**STATE OF CONNECTICUT  
CONNECTICUT SITING COUNCIL**

**Petition No. 1424**

**September 22, 2020**

**SOUTHINGTON SOLAR ONE, LLC'S RESPONSES TO THE CONNECTICUT  
SITING COUNCIL'S FIRST AND SECOND SETS OF INTERROGATORIES**

Figure 1: Location of Wildflower Pollinator Area

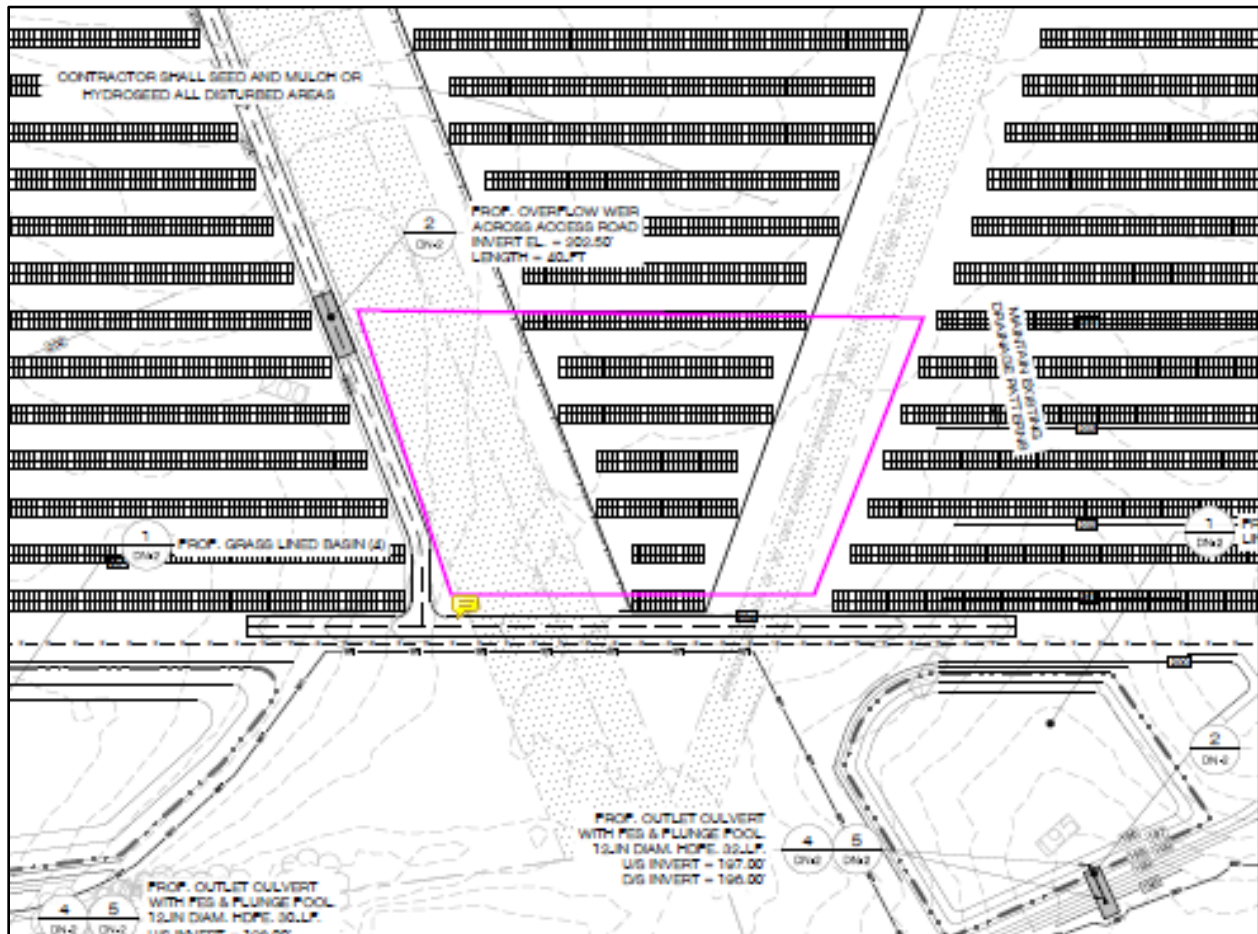
17. **Please indicate the location of the Wildflower Pollinator Area on diagram. What is the size of the pollinator area?**

A Wildflower Pollinator Area was originally proposed by the Petitioner in the southwestern portion of the Project Area. This area has now been relocated after meeting with the tenant farmer on the property in June. The reasoning for relocation was to allow for continued and future agricultural use of this location. The relocated Wildflower Pollinator Area is in the south-central portion of the fenced in array area. This habitat area will be over 1 acre in size and sown with a dedicated Wildflower Pollinator seed mix. The habitat area is delineated as the trapezoidal area depicted in Figure 1 below.

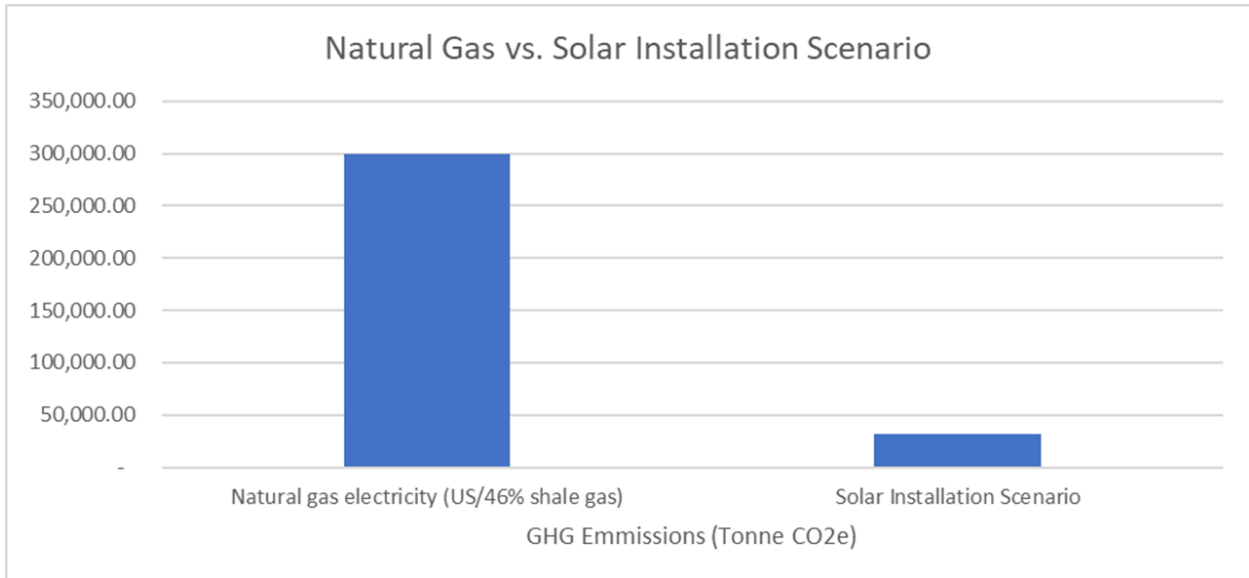
38. **Referring to Petition p. 39, why would the portion of the Critical Terrestrial Habitat (CTH) within the array area be considered developed if post-construction vegetation is similar to pre-existing conditions? Can any type of CTH habitat enhancement be used in a portion of the array area such as logs or thick layers of leaf litter?**

For purposes of the vernal pool analysis, the Critical Terrestrial Habitat (CTH) within the array areas is conservatively considered “developed” in the post-construction condition, based on the assumption that management of a solar facility precludes the potential for these areas to revert to high quality scrub/shrub and/or forested terrestrial habitat for vernal pool dependent herpetofauna. The Petitioner recognizes that this is a conservative approach, particularly given the existing and historical use of the Site as an active hay field that is mechanically managed on a routine basis, thereby stunting any potential conversion to higher quality terrestrial habitat (i.e., allowing it to revert to a scrub/shrub or forested condition). It is unlikely that vernal pool dependent herpetofauna are currently (or, in the future will be) using open field areas in a significant capacity, since they are considered suboptimal terrestrial habitat.

In order to maintain vegetation and permanently stabilize soils within and around the arrays, typical habitat enhancement measures (such as adding logs or thick layers of leaf litter) are not feasible and would not improve overstory conditions. Implementation of potential enhancement measures within the array areas would result in a *de minimis* improvement to the habitat quality with respect to herpetofauna utilization. Without an overstory of woody vegetation for protection (among other functions), it is unlikely that vernal pool dependent species would use the open field habitat provided within the array area for extended periods of time. Therefore, due to logistical maintenance issues and the inability of the array areas to support functionally important terrestrial habitat, no habitat enhancement measures are proposed. However, logs will be added to the proposed Vernal Pool Mitigation Area to provide microhabitat and cover for herpetofauna to further enhance the mitigation area.
